TO:	Planning Office	SUBJECT:	POD2013-00312: McDonald's Mechanicsville Tnpk Remodel
FROM:	Henrico County Police Division, Community Services Unit	DATE:	September 19, 2013

POD2013-00312

McDonald's Mechanicsville Turnpike Remodel

<handicap parking improvements and addition of dual drive thru lanes >

Photo A. Shielded wall pack.

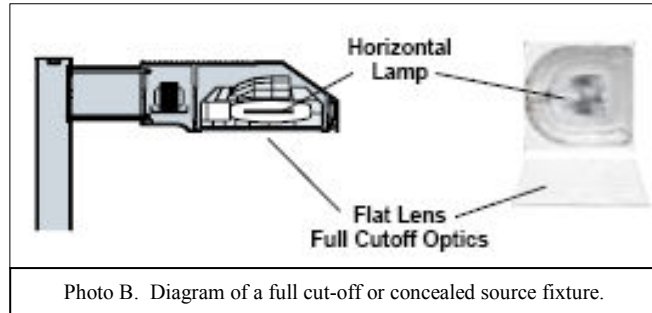
7. All light fixtures need to be full cut-off. See Photo's A and B for examples of full cut-off wall packs and pole lights.
8. Should post top fixtures be used, these fixtures also need to be full cut-off so that the light will be directed down to the ground, versus horizontally and up in the air. If decorative fixtures are installed, they should have the lamp in the top casing of the fixture so that the light will be directed towards the ground (See Photo C). This will also avoid glare because you don't actually see the lamp. Glare is defined as horizontal light that hinders vision.
